ADDENDUM No. 1

RFP No. 25-58

Access Control for City of Ann Arbor Dog Parks

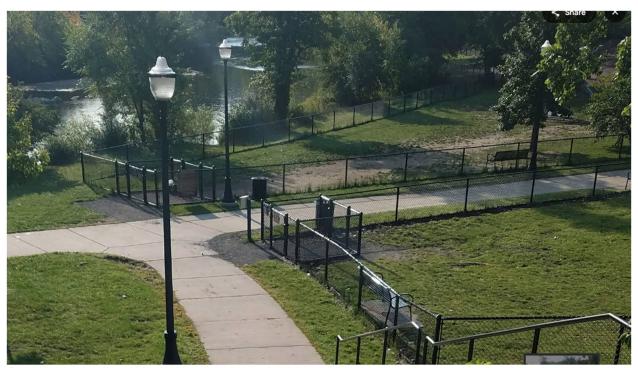
Question 11: What type of openings are going to be receiving access control? Standard doors, gates etc? Ideally, we would like to set up a site visit to each of the parks to identify and document these openings, their relation to the building, get an idea of any conduit needed, etc. If a site visit is not permitted, pictures both inside and out of each opening in order to provide the turnkey proposal requested is required.

Answer 11: The gates are chain-link fences with lift-up latches. We understand that we will likely need to install something different for these entryways as part of this project. Images of gates are provided below.
